Component Update - NTA5318 Back Leak Adaptor Change Update TSN012

Technical Support Note TSN012 v1, 21.07.2022

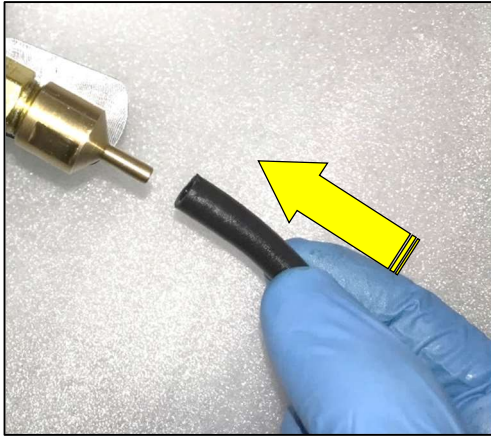
Due to the availability of parts related to difficulties within our supply chain, the Part contained in NTA5318 has now been changed. A temporary measure was put in place in June 2022 as confirmed in TSN010.

This change has now become permanent as of July 2022

The following process details the correct installation of the New NTA5318 Backleak Adaptor:
